**EXHIBIT LIST FOR SUB 2022-004/EA 2022-051  
Preliminary Plat of Blair Loop**

### STAFF REPORT TO THE BENTON COUNTY PLANNING COMMISSION

<b>FILE NO:</b>	SUB 2022-004 Preliminary Plat of Blair Loop
<b>MEMO DATE:</b>	August 2, 2023
<b>HEARING DATE:</b>	August 8, 2023
<b>APPLICANT/ OWNER</b>	Jerrold Sessler RQ Bradley, LLC, 84009 W OIE Hwy Prosser, WA 99350
<b>LOCATION:</b>	The site is located in unincorporated Benton County south of Old Inland Empire Highway in Sections 22 and 27, Township 9 North, Range 25 East, W.M. in Prosser, WA on parcel numbers 122954000004000, 127951000004000, and 127951000002000.
<b>PROPERTY SIZE:</b>	Approximately 64.70 acres
<b>AREA TO BE USED:</b>	Approximately 61.20 acres
<b>LAND USE:</b>	Residential
<b>COMP. PLAN:</b>	Rural Remote
<b>ZONING:</b>	Rural Lands Five Acre District
<b>SUGGESTED STAFF RECOMMENDATION:</b>	Positive recommendation subject to seven (7) findings of fact and twenty (20) conditions of approval.

PRELIMINARY PLAT OF BLAIR LOOP DEV

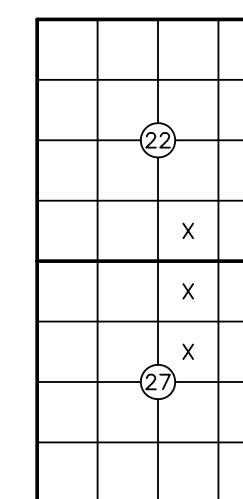
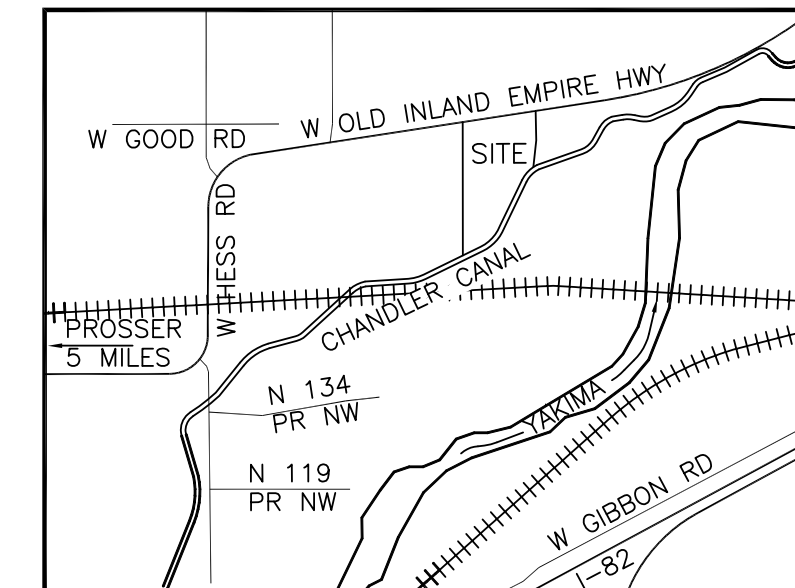
As we recently discussed, it has been determined a revised plat map is necessary for Preliminary Plat SUB 2022-004 and EA 2022-051.

Benton County has determined that the plat map initially submitted with the application does not show existing structures on the property. Showing the location of these permanent buildings on the plat map is required by Benton County Code 9.05.060(b)(1).

With the need for a revised and accurate plat map for agencies to review, your application will be placed on a hold up to 60 days to allow you time to have the map updated. Once a revised map is submitted, our office will continue the processing of your subdivision application.
